## SERVICE BULLETIN

ENGINE - INLET CONE - INTRODUCTION OF SEALS ON THE INLET CONE FAIRING - [C]CATEGORY  
CODE 8 - CATEGORY CODE 5 - MOD.ENG-72-0318

# V2500-ENG-72-0318

Modification of the Inlet Cone Fairing  
Fig.1

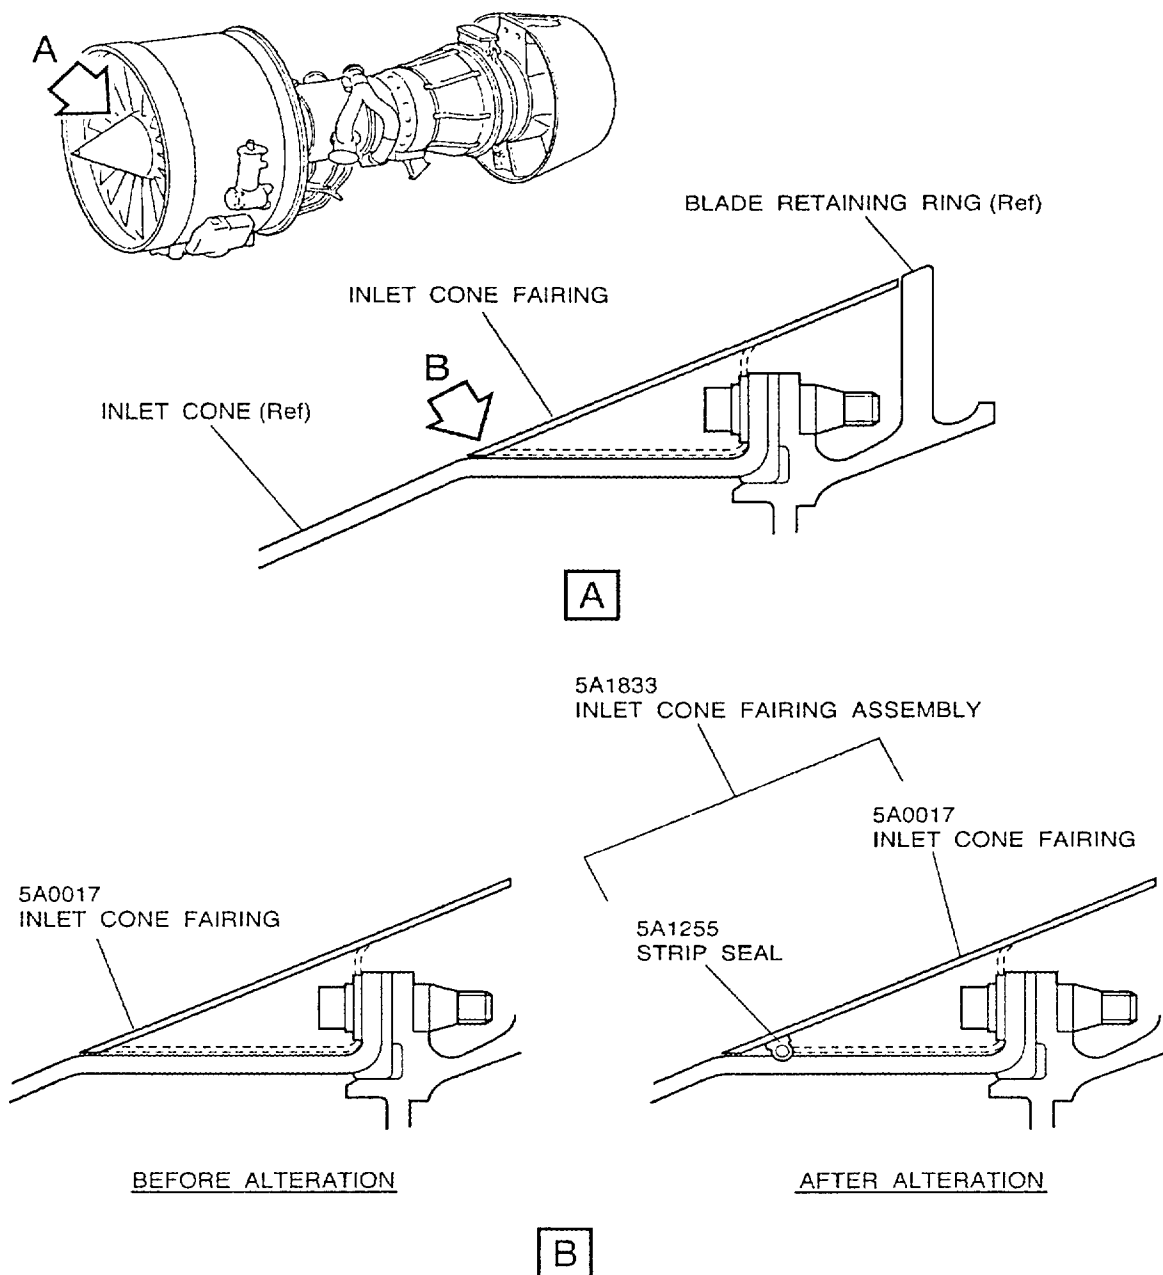
A new inlet cone fairing which has strip seals is introduced.

(2) The modification is accomplished when the six strip seals are installed at the forward lip of the inlet cone fairing. The existing inlet cone fairing can be reworked, see Figure 2. The 5A1255 strip seal is necessary to do the modification.

Rework of the Inlet Cone Fairing  
Fig.2 (Sheet 1 of 2)

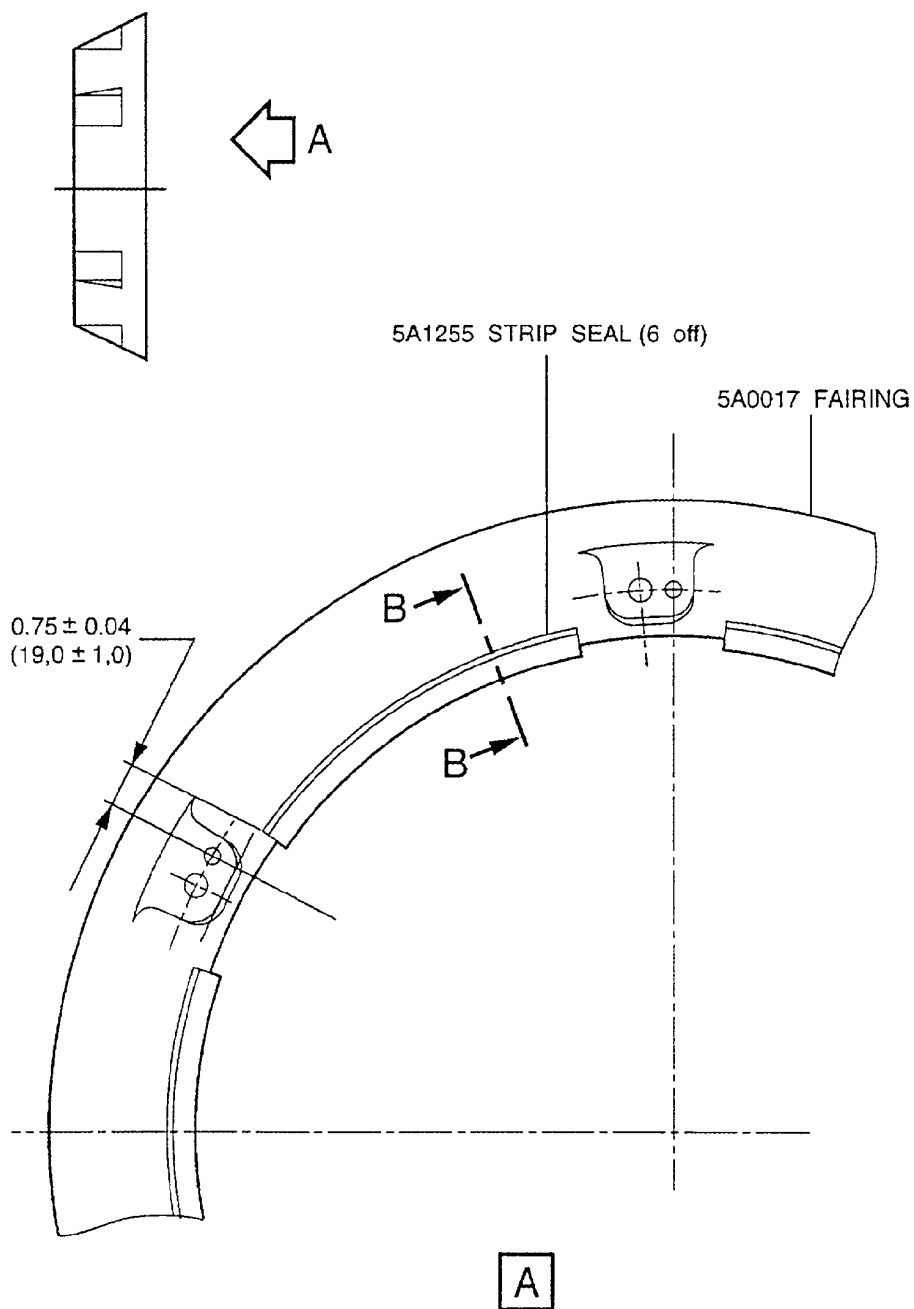
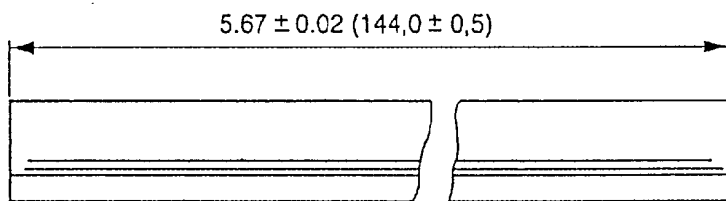
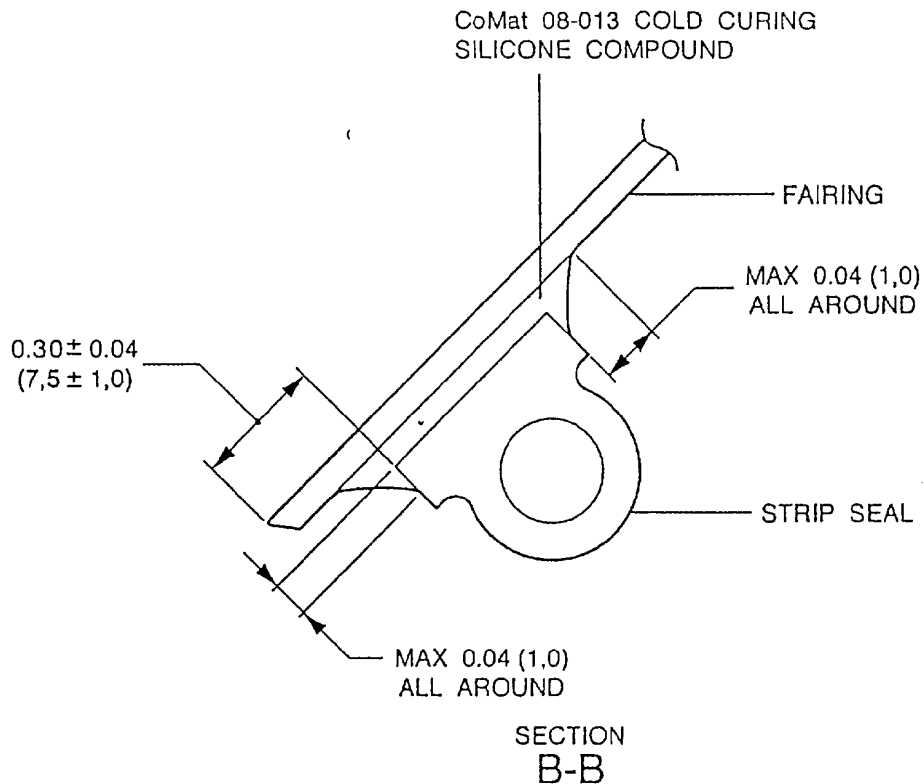
Procedure	Supplementary Information
(a) Prepare the six strip seals.	Use the 5A1255 strip seal. Cut the strip seals and adjust the length. Refer to Figure 2.
(b) Hand clean the fairing surfaces which the strip seals are attached on.	Use CoMat 05-016 garnet paper or CoMat 05-017 garnet paper.
(c) Degrease the fairing surfaces.	Use CoMat 01-076 methyl ethyl ketone $\text{CH}_3\text{CO C}_2\text{H}_5$ . Refer to SPM Task 70-36-02-360-501.
NOTE: The primer must be applied immediately after the surfaces are degreased.	
(d) Apply a thin layer of primer on the fairing surfaces, where the strip seals will be attached.	Use CoMat 08-014 primer. Refer to SPM Task 70-36-02-360-501. Dry in the air for 30 minutes.
(e) Apply silicone compound on the mating surface of each strip seal.	Use a spatula and CoMat 08-013 cold curing silicone compound. Refer to SPM Task 70-36-02-360-501.

| (f) Attach the strip seals on the fairing.  | Put force to the strip seal.<br>Make sure of the bonding condition.                                |
| (g) Use adhesive tape and hold the six strip seals.   | Use an applicable adhesive tape.   |
| (k) Mark the re-number adjacent to the existing part number of inlet cone fairing. Use the Electrolytic etch method if available. Alternatively make a mark with ink. | Existing          Re-number<br>5A0017          5A1833<br>Refer to the SPM<br>TASK 70-09-00-400-501 |
